Service Bulletin

PRELIMINARY INFORMATION

Subject: Warm Air Exhausting from Driver and/or Passenger Front Seat Back into 2nd Row Seating Area Causing Occupant Discomfort

Models: 2015 Cadillac Escalade Models
2014 Chevrolet Silverado 1500
2015 Chevrolet Silverado, Suburban, Tahoe
2014 GMC Sierra 1500
2015 GMC Sierra, Yukon Models
Equipped with Heated and Cooled Seats - Driver and Passenger Front (RPO KB6)

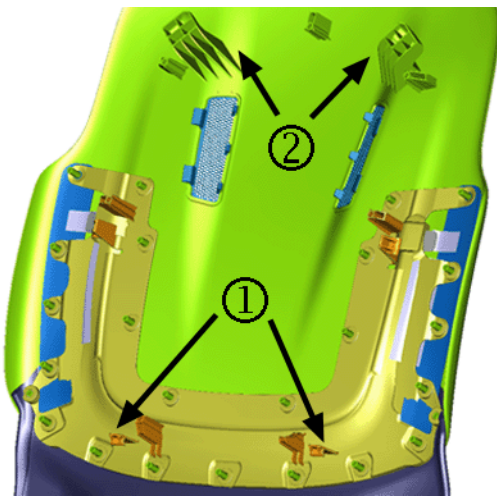
Some customers may comment on warm air exhausting from the driver/passenger front seat back into the 2nd row seating area, causing occupant discomfort.

The cause of this condition may be that during cooled seat operation, a direct flow of warm air exhausts from the upper seat back ventilation heating/cooling blower.

It has been found that removal of the exhaust duct (1) on the upper seat back ventilation blower allows for a less direct air exhaust and disperses the warm air more thoroughly within the seat back cushion. Remove the upper ventilation blower duct from BOTH the driver and passenger seats using the following steps:

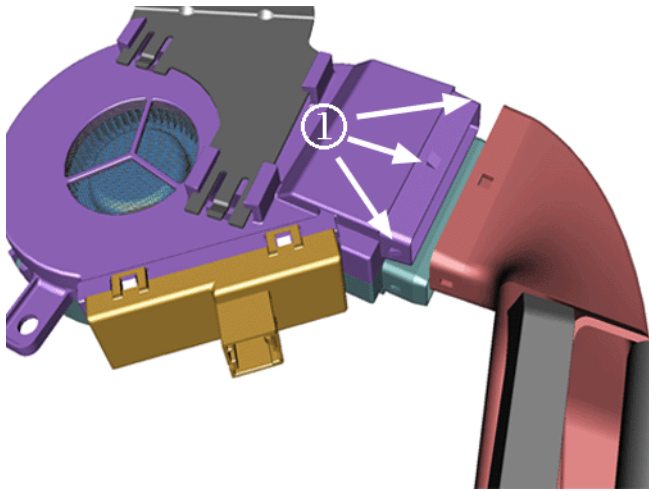
Caution: To help avoid damage to the seat back finish panel, after detaching the lower bungee clips, carefully lift the bottom of the finish panel high enough for the lower retainers (1) to disengage from the seat frame. Once the lower retainers are released, tilt the finish panel to one side, then the other, to disengage the upper retainers (2).

1. Starting on the driver or passenger front seat, remove the front seat back cushion finish panel. Refer to Front Seat Back Cushion Finish Panel Replacement in SI.

2. Locate the ventilation blower exhaust duct. Depending on the vehicle, the duct may look like either example shown in the graphic above.
